**F & S SUBDIVISION,**  
**RESUBDIVISION OF LOTS 1 & 2**

APPLICATION NUMBER 25 DATE July 19, 2007

REQUEST Subdivision

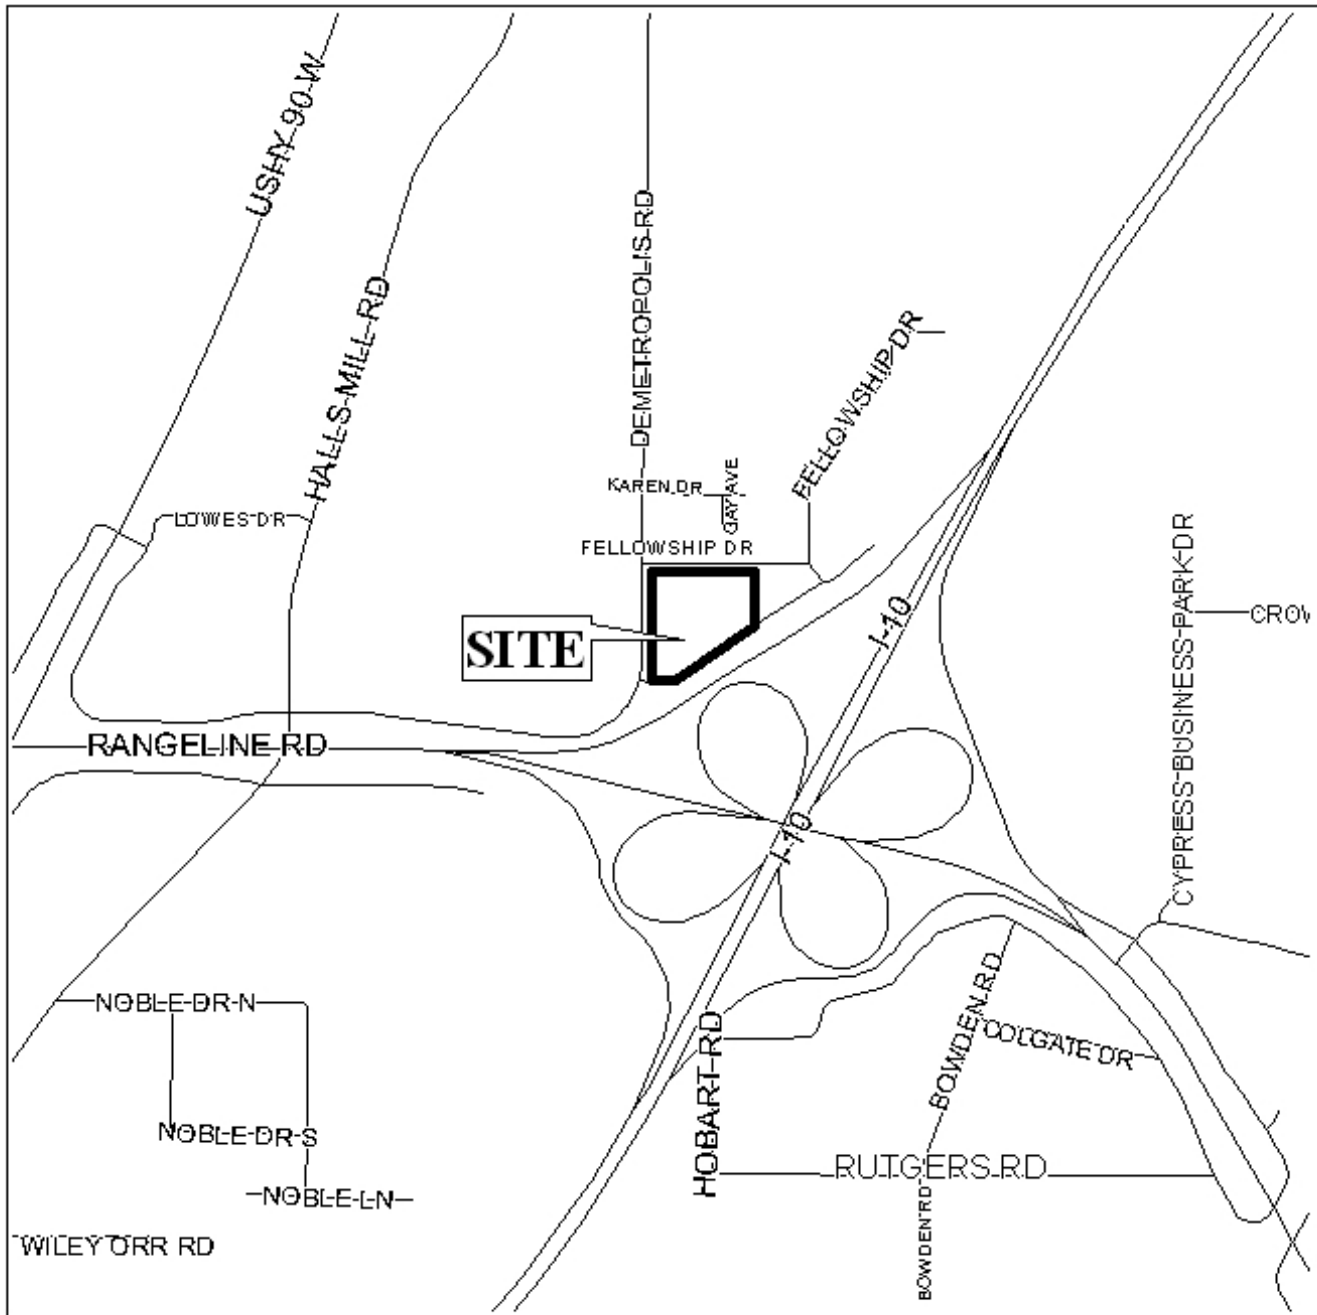
The plat illustrates the 25-foot minimum building setbacks on all street frontages.

Given the amount of street frontage, the proposed Lot 1A should be limited to the existing curb cuts, the proposed Lot 2A should be limited to two curb cuts to Demetropolis Road, and one curb cut to Executive Park Drive, and the proposed Lot 3A should be limited to one curb cut to Fellowship Drive and one curb cut to Executive Park Drive, with the size, location, and design of all curb cuts to be approved by County Engineering.

The plat does not label the amount of road frontage along Executive Park Drive for the proposed Lot 2A or the proposed Lot 3A, as such, this labeling should be required prior to the signing of the final plat. Also, the right-of-way width of Executive Park Drive is not illustrated, and illustration of such should be provided.

This site is located in the County, thus a note should be placed on the final plat stating that any lots which are developed commercially and adjoin residentially developed property must provide a buffer, in compliance with Section V.A.7. of the Subdivision Regulations.

The site will have to comply with the City of Mobile storm water and flood control ordinances. A note should be placed on the final plat stating that the development will be designed to comply with the storm water detention and drainage facility requirements of the City of Mobile storm water and flood control ordinances, and requiring submission of certification from a licensed engineer certifying that the design complies with the storm water detention and drainage facility requirements of the City of Mobile storm water and flood control ordinances prior to the issuance of any permits. Certification is to be submitted to the Planning Section of Urban Development and County Engineering.

The plat should show the size, in square feet, of each lot, or a table with the same information should be provided.

- 1) provision of a note on the final plat stating that Lot 1A is limited to the existing curb cuts, Lot 2A is limited to two curb cuts to Demetropolis Road, and one curb cut to Executive Park Drive, and Lot 3A is limited to one curb cut to Fellowship Drive and one curb cut to Executive Park Drive, with the size, location, and design of all curb cuts to be approved by County Engineering;

- 2) labeling of the amount of road frontage along Executive Park Drive for the Lot 2A and Lot 3A;
- 3) labeling of the right-of-way width of Executive Park Drive;

- 4) labeling of each lot with the size, in square feet, or provision of a table with the same information;
- 5) provision of a note should be placed on the final plat stating that any lots which are developed commercially and adjoin residentially developed property must provide a buffer, in compliance with Section V.A.7. of the Subdivision Regulations; and

- 6) provision of a note on the final plat stating that the development will be designed to comply with the storm water detention and drainage facility requirements of the City of Mobile storm water and flood control ordinances, and requiring submission of certification from a licensed engineer certifying that the design complies with the storm water detention and drainage facility requirements of the City of Mobile storm water and flood control ordinances prior to the issuance of any permits. Certification is to be submitted to the Planning Section of Urban Development and County Engineering.
